Preliminary Consultation
MONTGOMERY COUNTY HISTORIC PRESERVATION COMMISSION
STAFF REPORT

Address:	15 Columbia Ave., Takoma Park	Meeting Date:	6/9/2021
Resource:	Non-Contributing Resource Takoma Park Historic District	Report Date:	6/2/2021
Applicant:	Wakako Tokunga	Public Notice:	5/26/2021
Review:	Preliminary Consultation	Staff:	Dan Bruechert
Proposal:	Building Alterations, Rear Addition, Hardscape Alteration, and Accessory Structure Construction

FLOOR PLANS

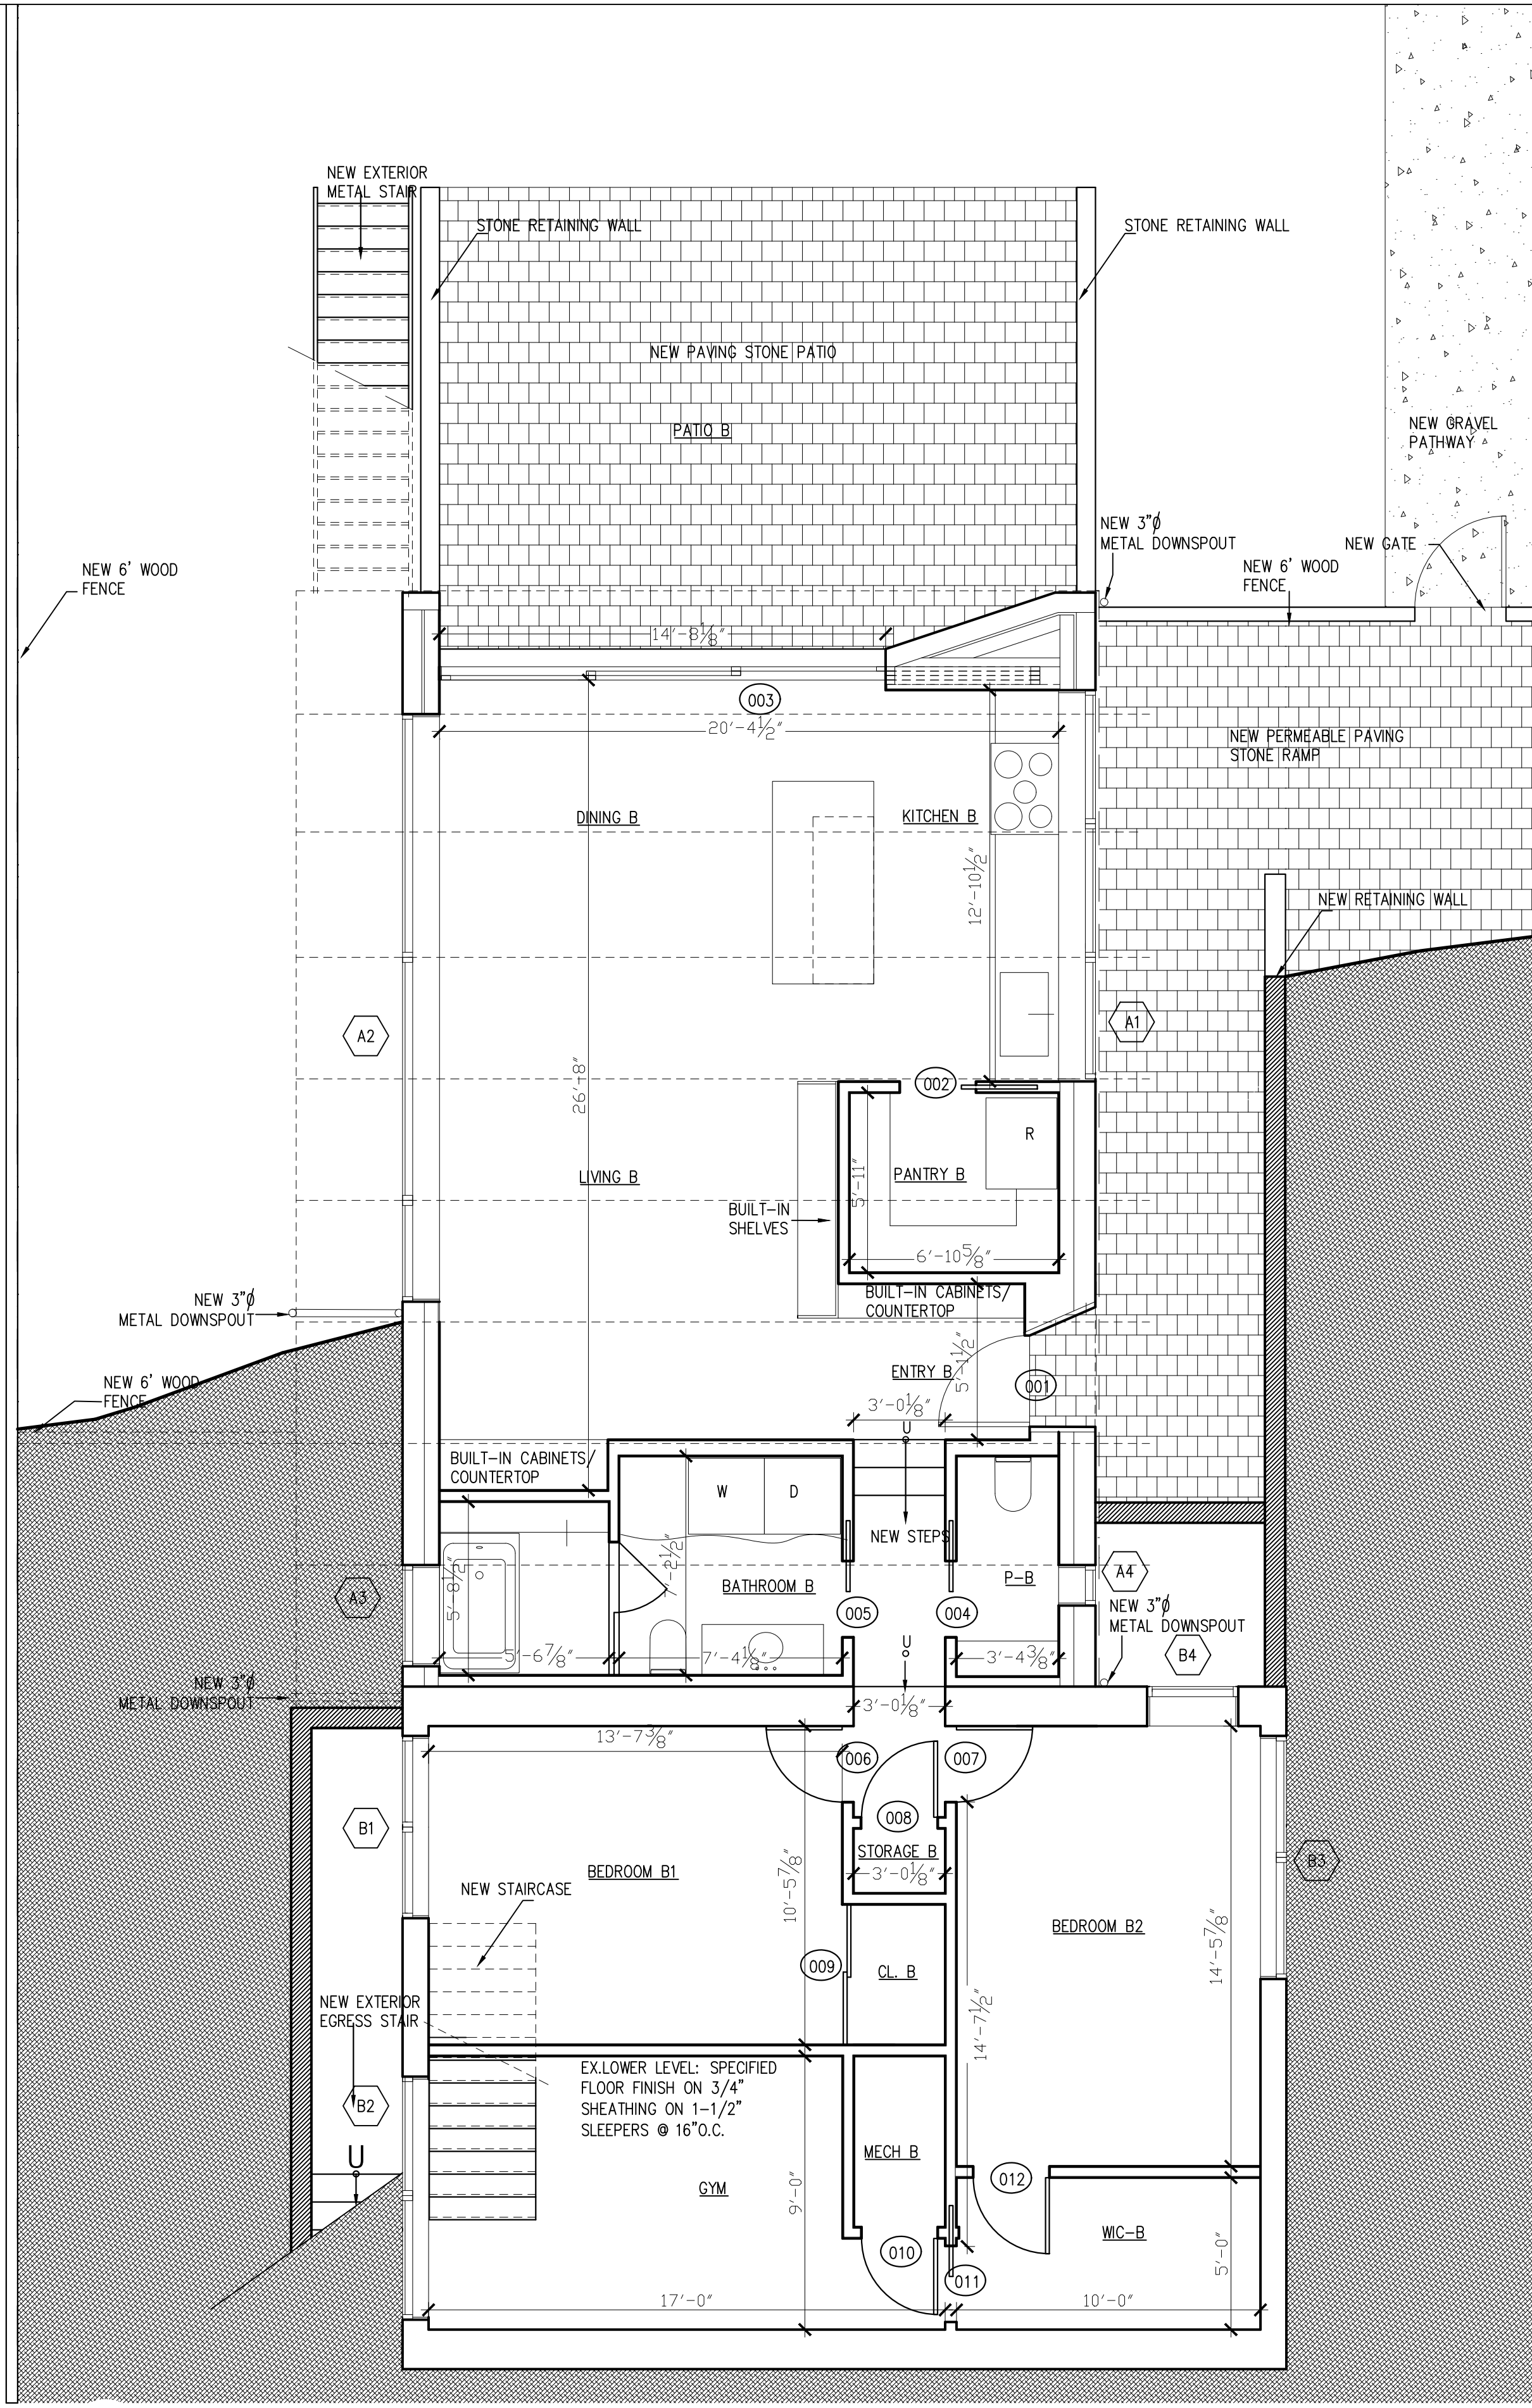
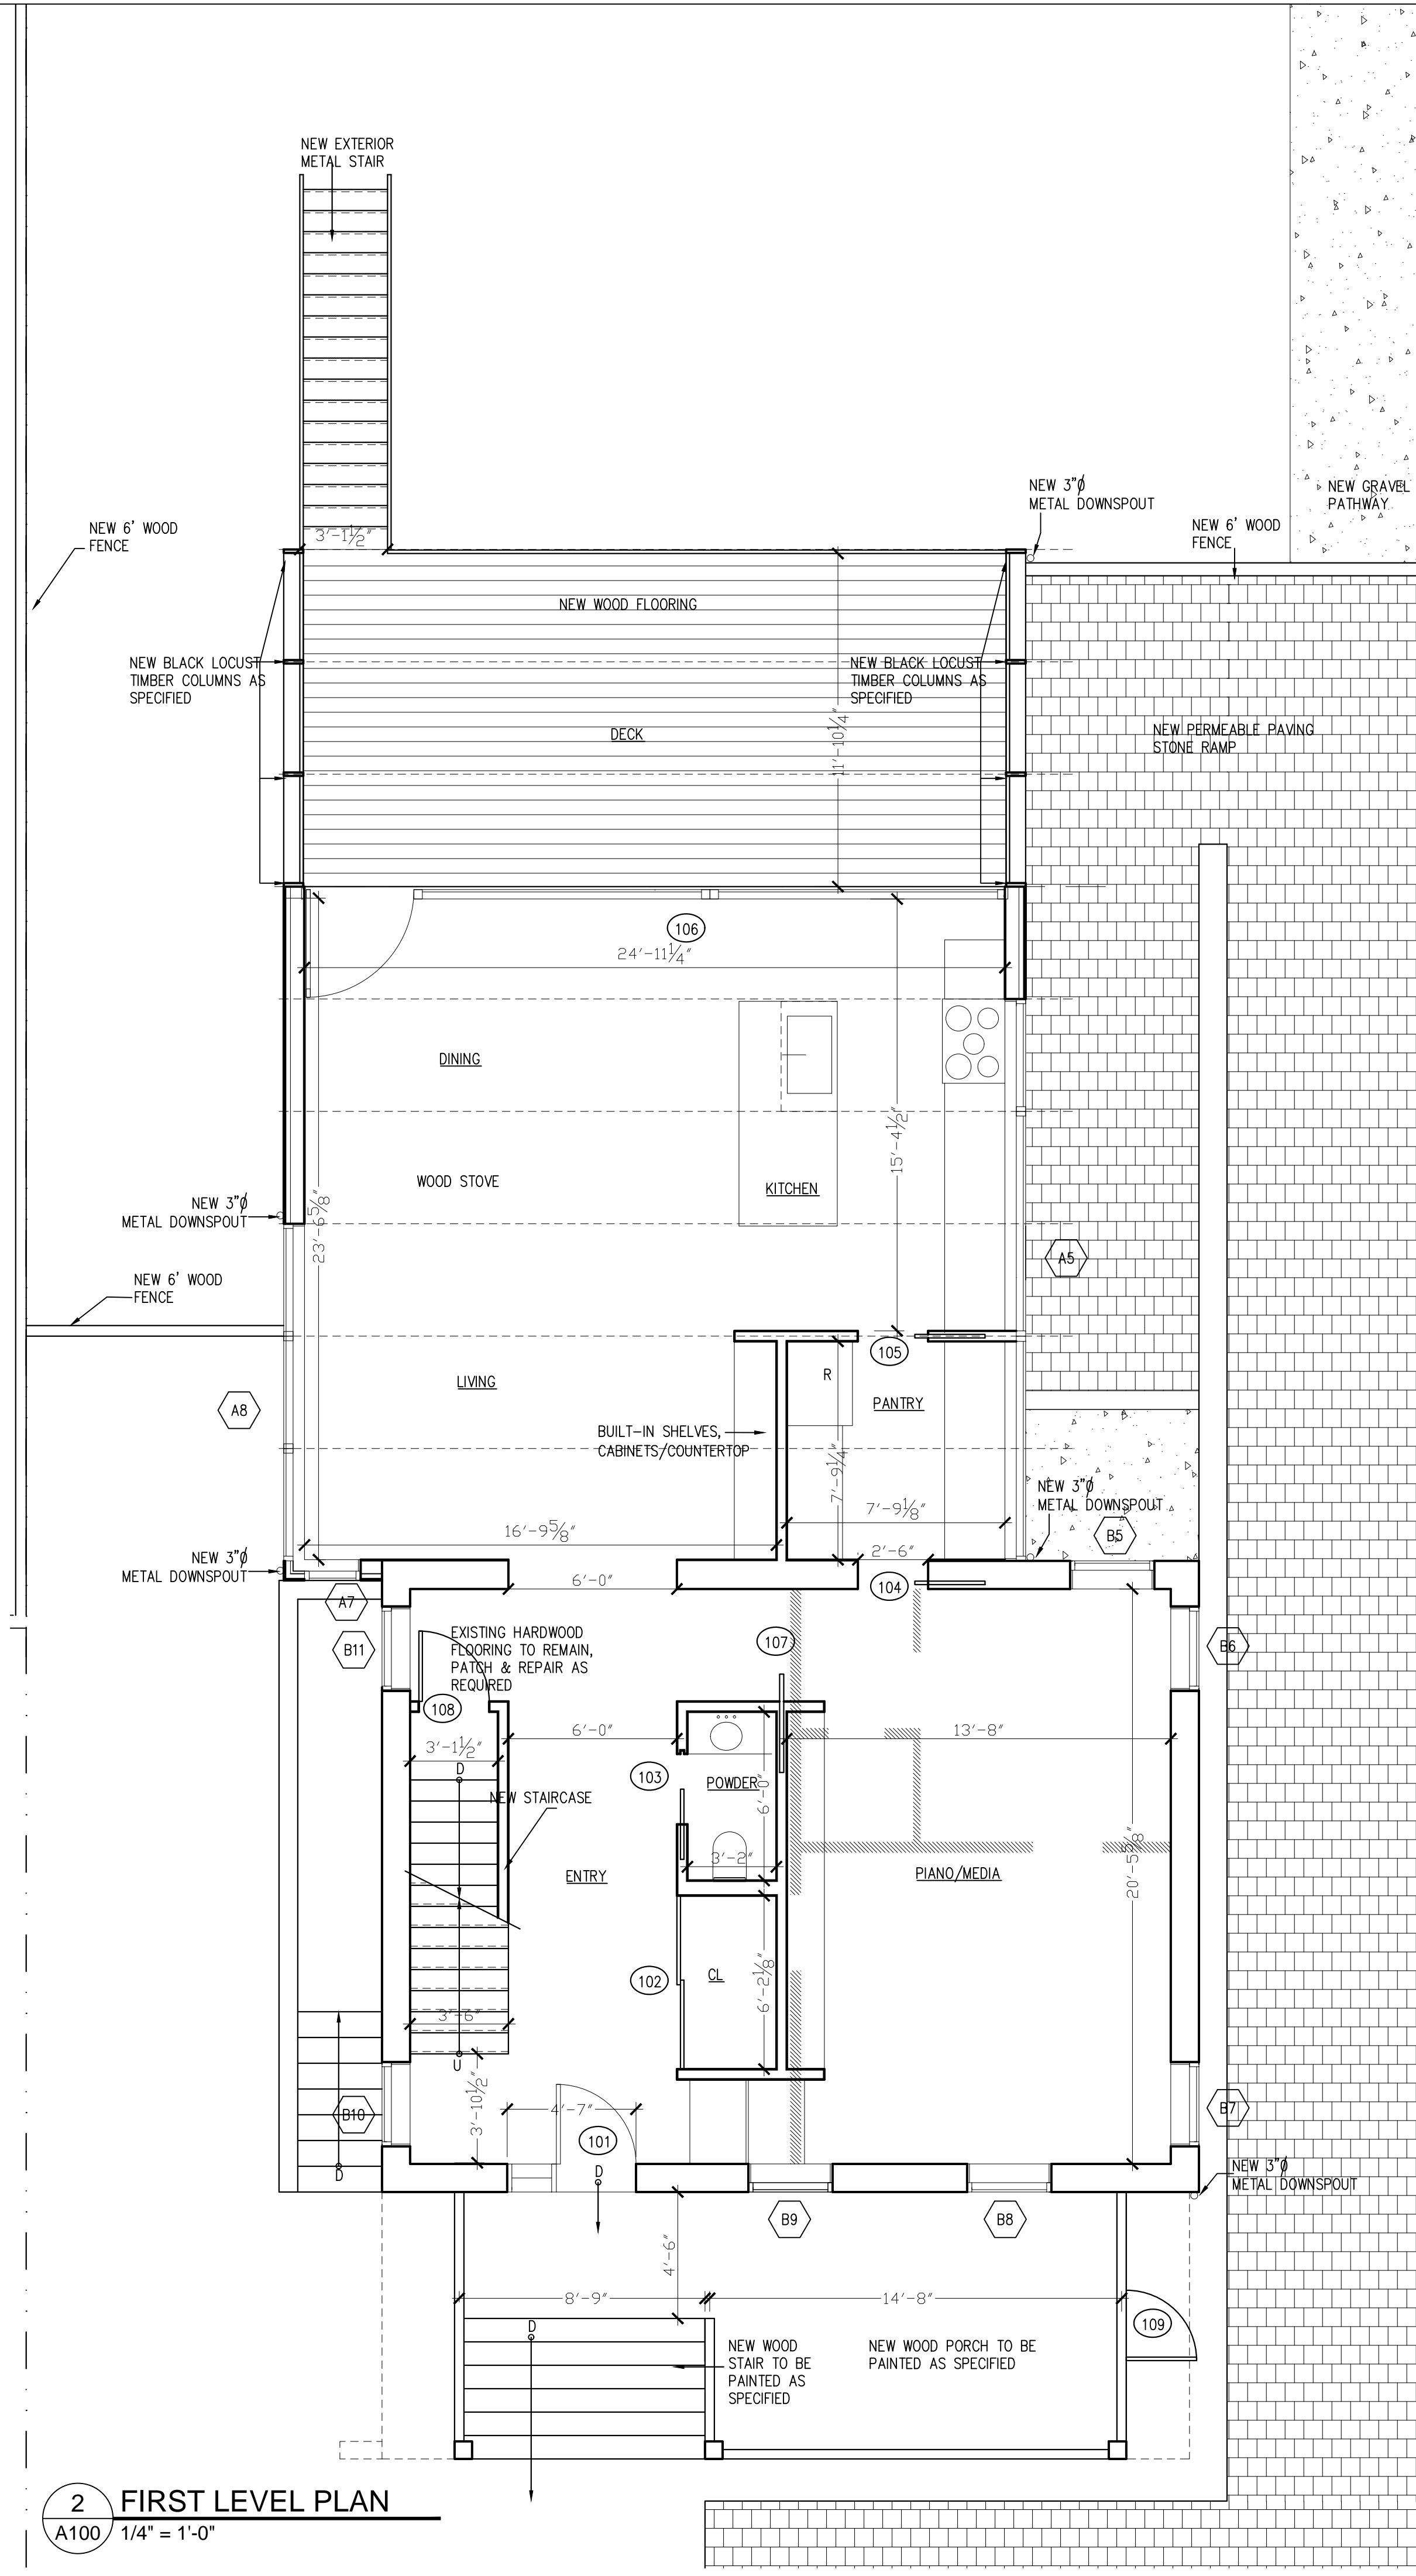
The larger question for the HPC is the appropriateness of the placement, size, and massing of the proposed addition. Staff finds the footprint of the proposed addition is approximately the same size as the approved addition at 13 Columbia Ave. (the applicant and Staff Report for the 2016 HAWP and preliminary consultation are attached).

Typically, additions are required to be inset from the historic wall planes. The goal of that requirement is to retain the primacy of the historic resource, however, the subject resource is not historically significant. Staff finds the evaluation of the addition's placement and its left side projection needs to be focused on the impact on the surrounding streetscape. The right side of the addition is inset so that it will not be visible from the right of way. Because of the lot's unique shape, which curves with the street, the left projection is set back much further from the public right-of-way, approximately 70' (seventy feet), than the right rear of the house. Staff requests feedback from the HPC on the appropriate placement of the proposed rear addition.

The second question for the HPC is whether the massing of the addition will negatively impact the character of the district as a whole. Because of the configuration of the subject property, Staff finds the addition will only be visible from the left side of the house. The addition is inset on the right, so it will only be minimally visible from the right; and the houses along Hickory Ave. block any view from the east. Staff finds that the two-story mass, which projects 3' 6" (three feet-six inches), will not negatively impair the character of the district as a whole, per the *Guidelines*.

At the front of the subject property, there is a narrow concrete walk to the front stairs and an asphalt parking pad. The applicant proposes to install a new permeable paver area at the front. Overall dimensions of this area were not included with the submission, however, it appears to be more than 30' (thirty feet) wide. The paving extends along the right side of the house and widens slightly at the rear. A retaining wall is planned for this area. No specifications were included for the retaining wall.

Staff also notes that the proposed paving does not extend to the front stairs and questions whether the drawings are accurate for the proposed work.

Staff finds that paving one-half of the front yard, even with a textured block, would detract from the streetscape and surrounding district. Staff recommends that the design be revised to reduce the amount of paving or changing the material to something similar in appearance to grasscrete that would preserve the appearance of the lawn. Staff requests the HPC provide feedback on the proposed hardscaping. Additionally, this proposal may not meet the front yard paving requirements of the zoning ordinance. The applicant should remove this section of the proposal from the application and return with a separate HAWP, if necessary.
